Location:	6501 Shattuck Avenue- See map on reverse
Assessor's Parcel Number:	016 142801102
Proposal:	Two Appeals of the Zoning Manager's Approvals: 1) to construct a 4-story mixed-use building with commercial space and parking on the ground floor and 18 residential units above; and 2) for two additional required permits for a Multifamily Dwelling Residential Facility and more than 20% of the required group open space on the roof which were not included on the previous public notice or original Decision Letter.
Applicant:	Moshe Dinar (510)759-2133
Owner:	Bruder, LLC
Appellant:	Appellant 1) Chris Hall Appellant 2) Caitlin Stuart
Case File Number:	APL19003 and APL20010
Original Case File Number:	CDV10185
Planning Permits Required:	Interim Conditional Use Permit for a density of 18 residential units where the General Plan allows for 31 units and the zoning only allows for 5 units; Minor Conditional Use Permit for a Multifamily Dwelling Residential Facility and parking to be setback less than 75 feet from the front property line, Regular Design Review for new construction; and Minor Variances to allow a 13-foot high garage podium structure to project 7 feet into the required 15-foot rea

A-0

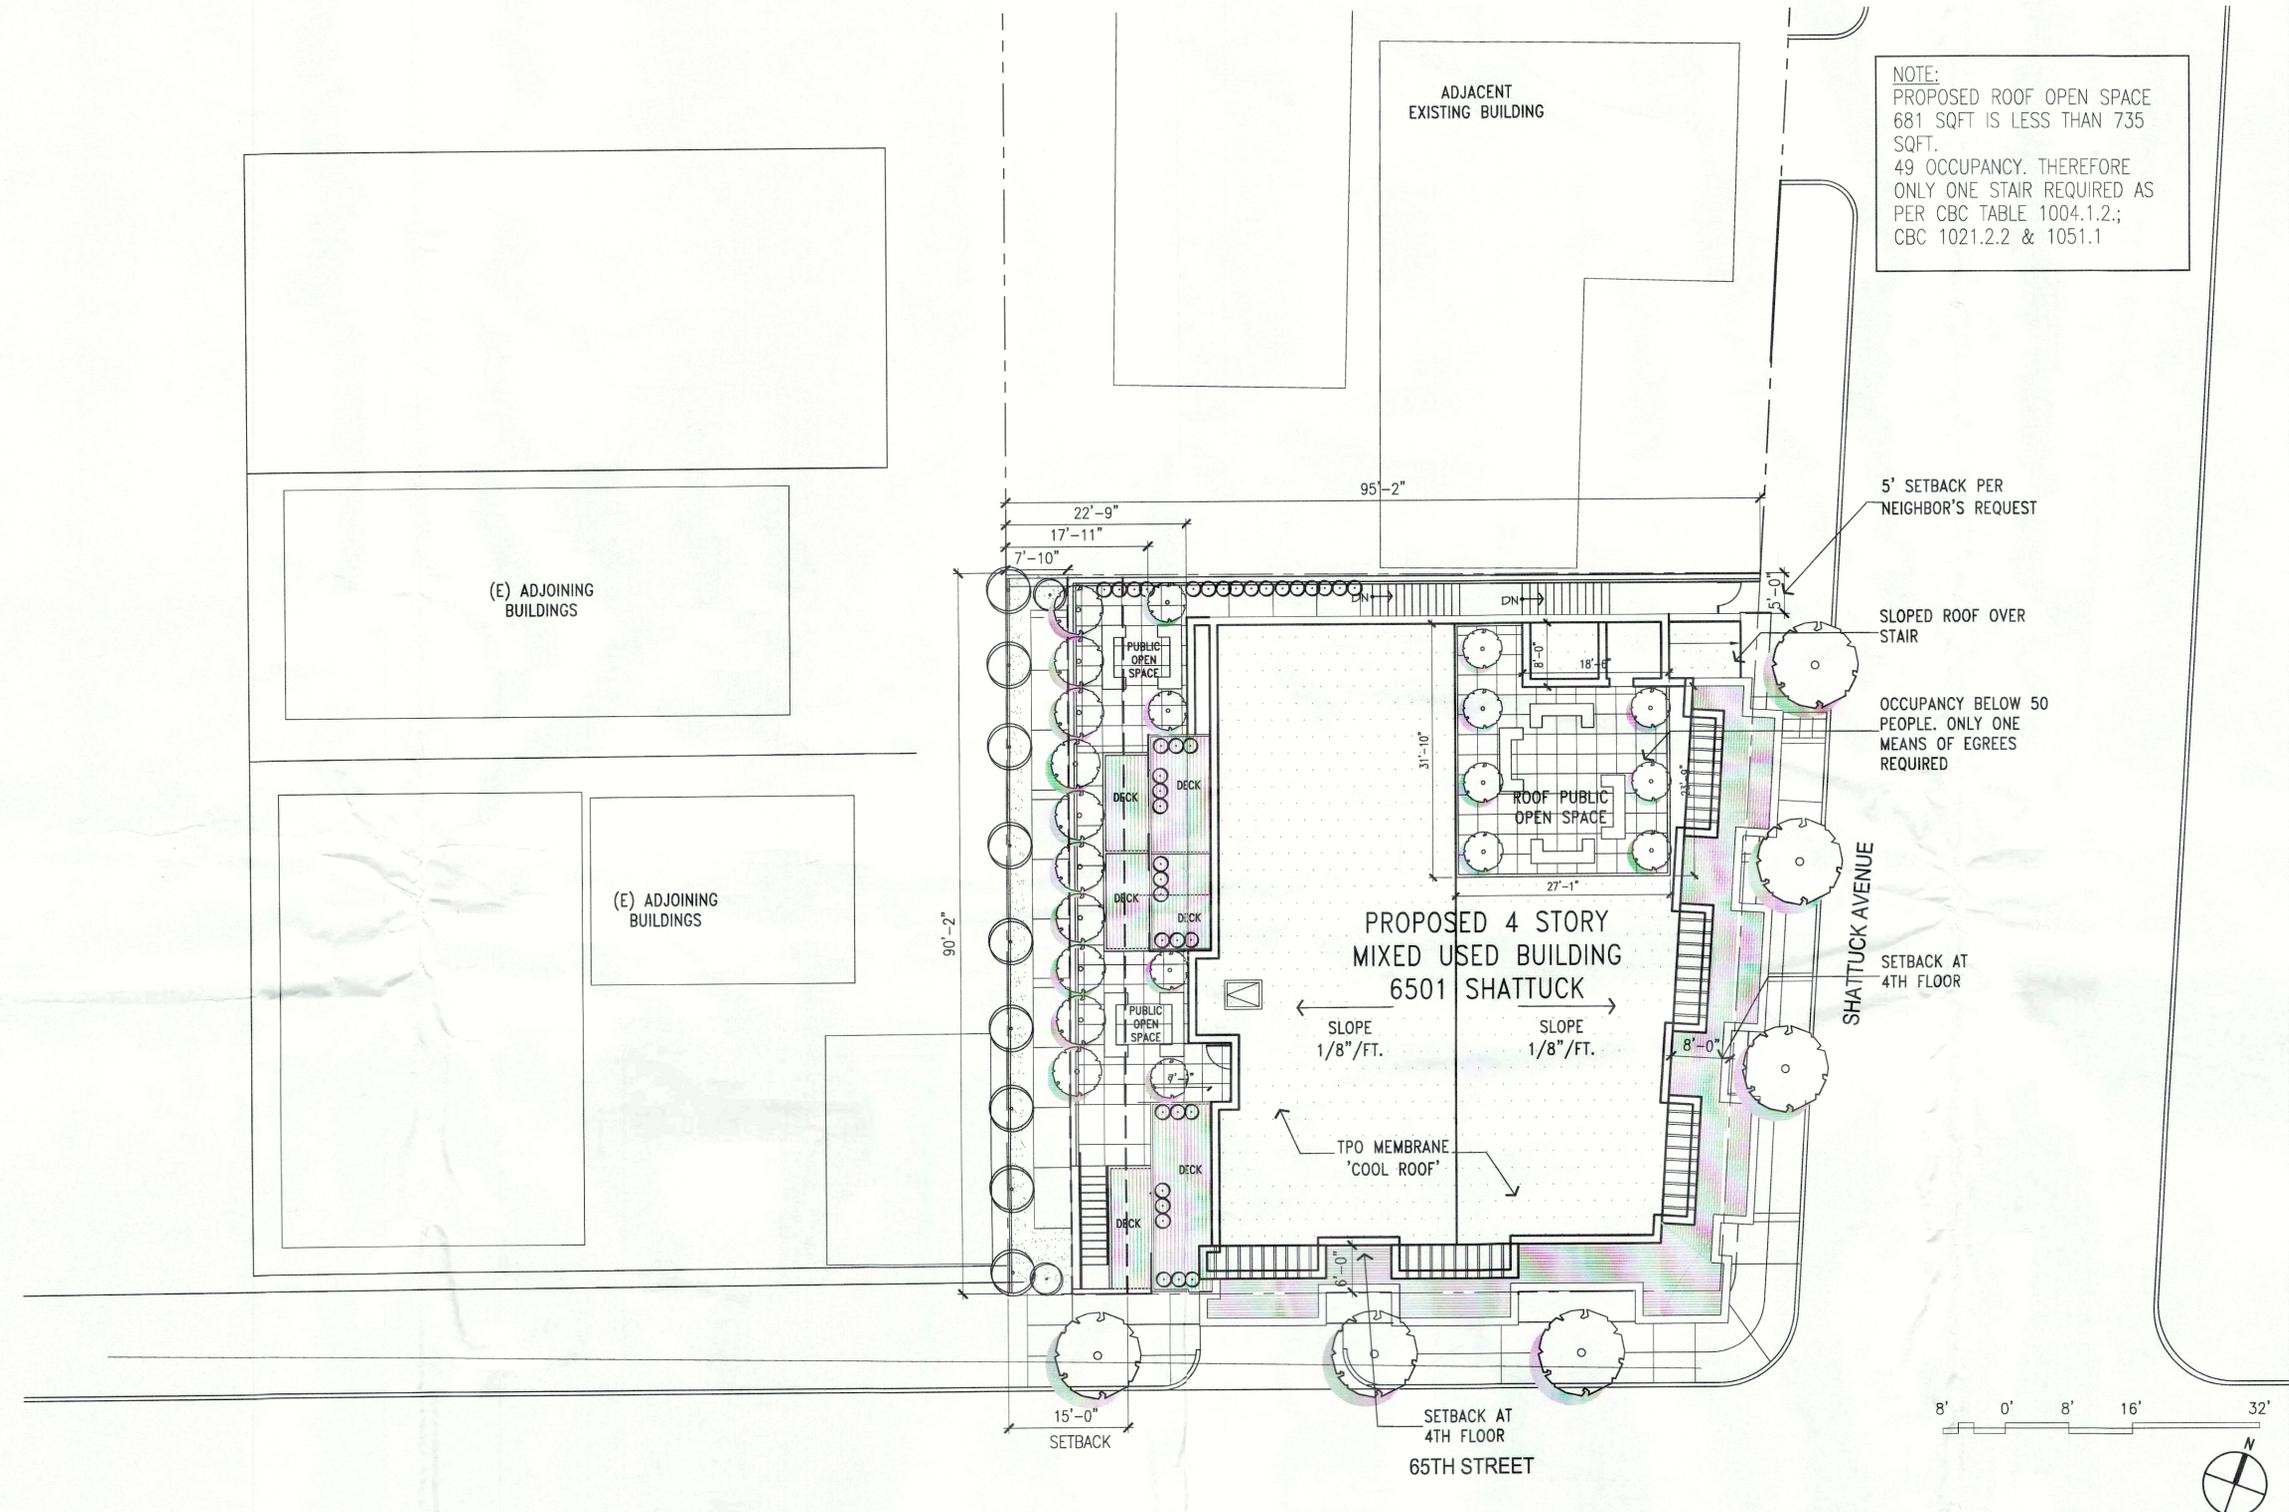
The application should have included a landscape plan by a licensed landscape architect. There are many landscape-related issues that need to be addressed. The site plan sheet A-0.1 shows a row of columnar trees at the rear of the property. These trees appear to be on top of a narrow screen wall on the property line. The trees should instead be placed next to the wall. Plus, the section on sheet A-5 shows the columnar tree located between the screen wall and a 6-foot CMU wall. This 6-foot CMU wall will

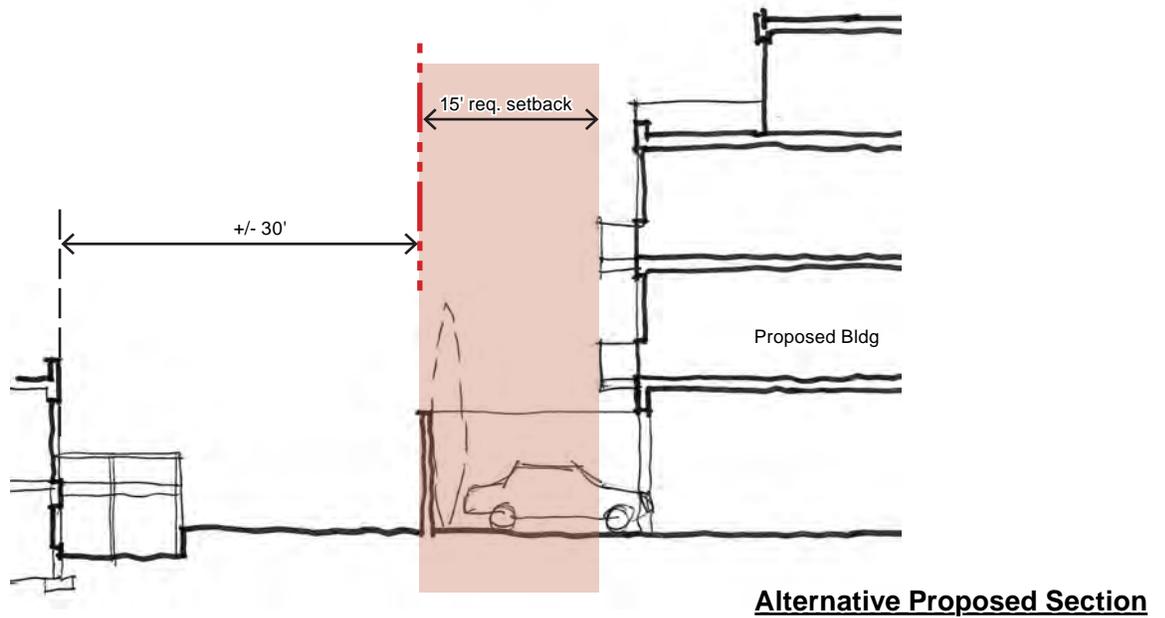
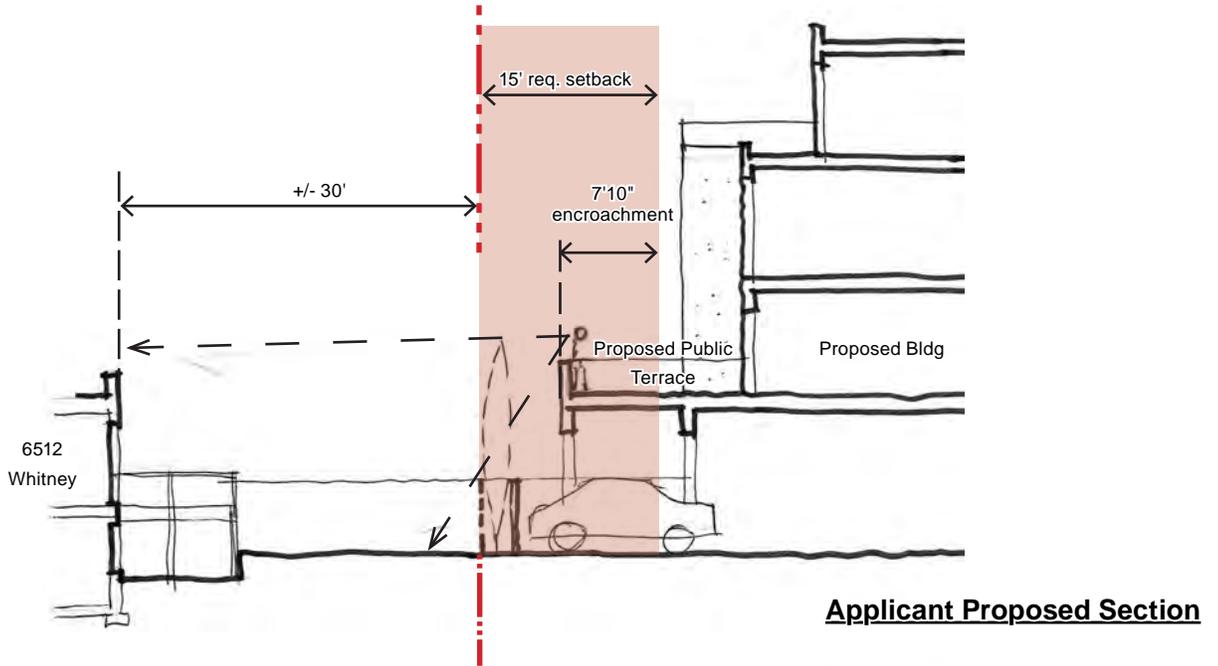
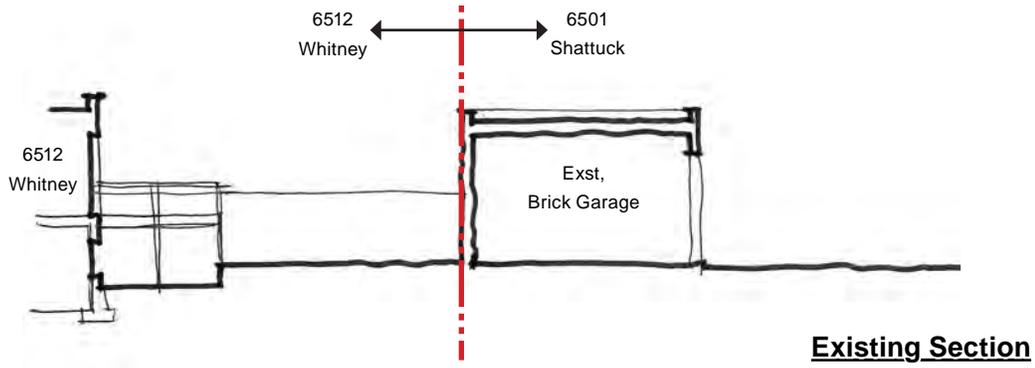
The Staff Report also says that the *‘intent of the rear setback is to restrain the building envelope’*. The purpose of a setback is that the building should not extend into it. While encroachments into setbacks are allowed for things like window bays, entry porches (front setback), stairs, and chimneys, the

encroachment here is for a podium raised 13' in the air for public gathering that will have a substantial impact on rear properties.

The Staff Report states that the proposed variance *'will not impact the neighbors due to screening walls and landscaping to buffer the adjacent properties'*. This is just false and seems to indicate that the plans were not carefully reviewed, and our complaint letters did not register. If you look at the location of the proposed podium open space and the design of the screen walls and landscape, you can clearly see that the visual and auditory privacy of rear properties will be severely impacted by this encroachment into the rear setback. There is a direct line for sight and sound to travel into our property. Our children are literally sleeping facing the back yard and we do not want to constantly be telling groups of people to quiet down. We respectfully ask that the Planning Commissioners and Staff carefully review the plan and sections.

Exhibit 2

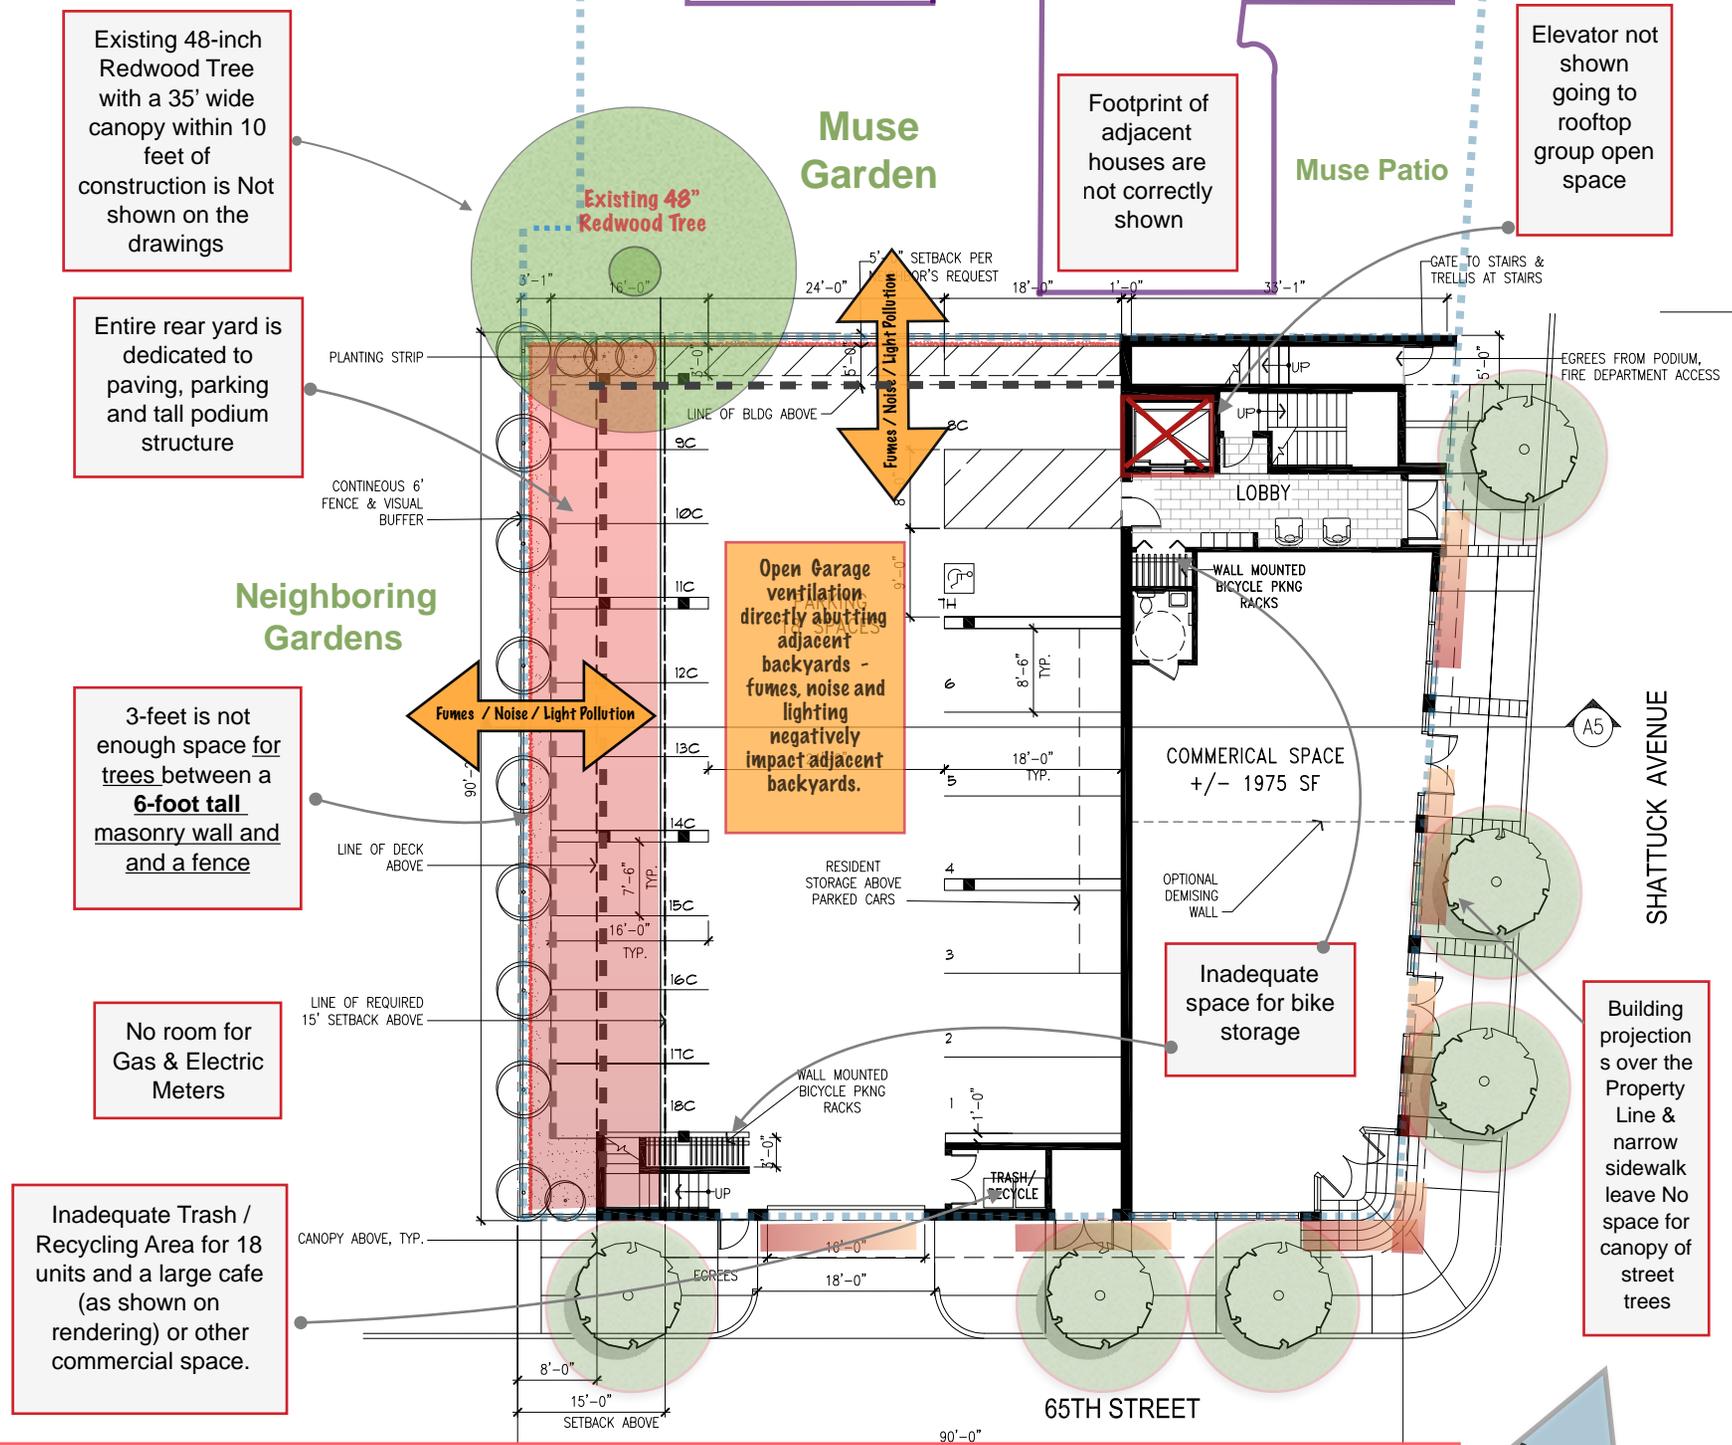
Existing 48-inch Redwood Tree with a 35' wide canopy within 10 feet of construction is Not shown on the drawings

Tall podium and fencing on top of it, and the corner of the upper levels, conflict with the Canopy of Existing 48-inch Redwood Tree within 10 feet of construction.

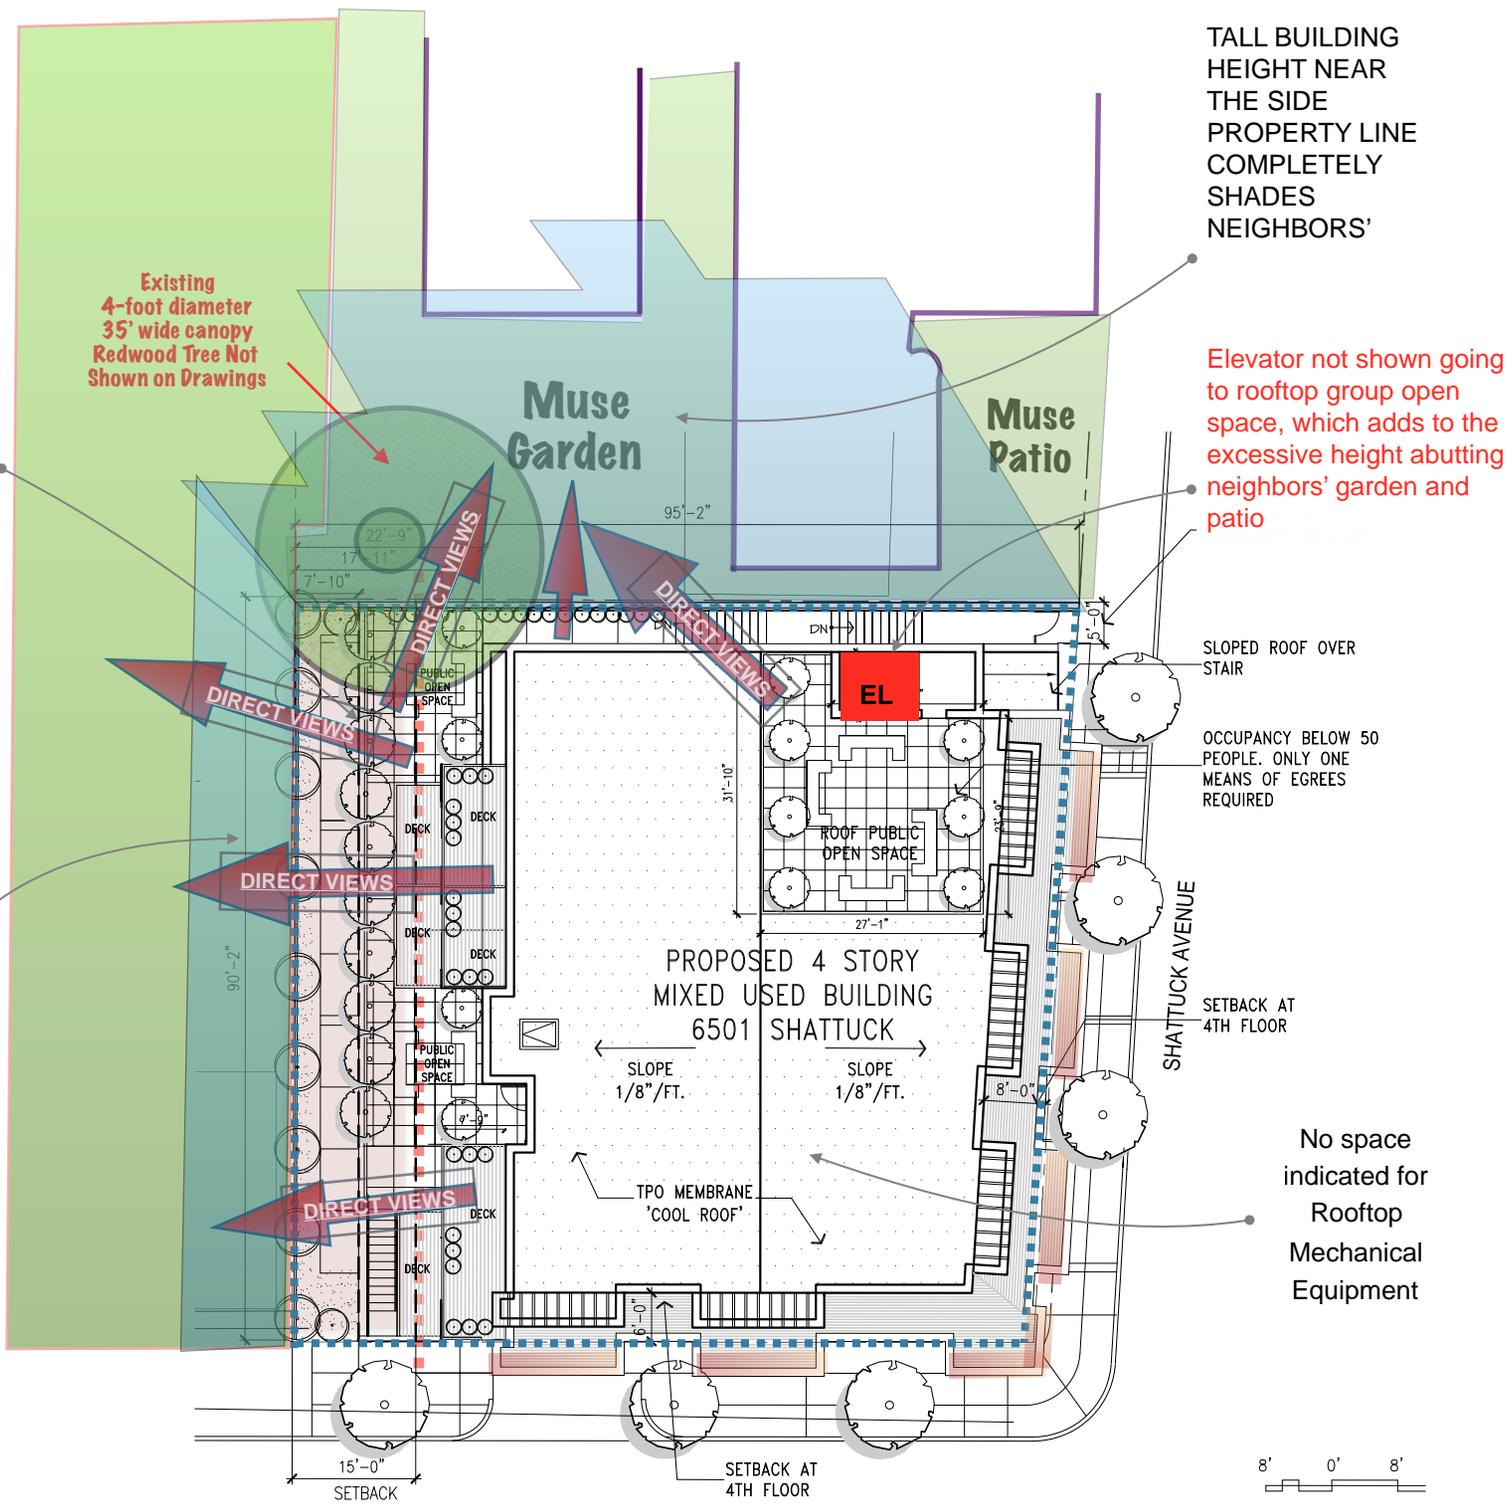
Direct views into neighboring backyards From elevated, open stairs walkways, rear decks and rooftop open spaces
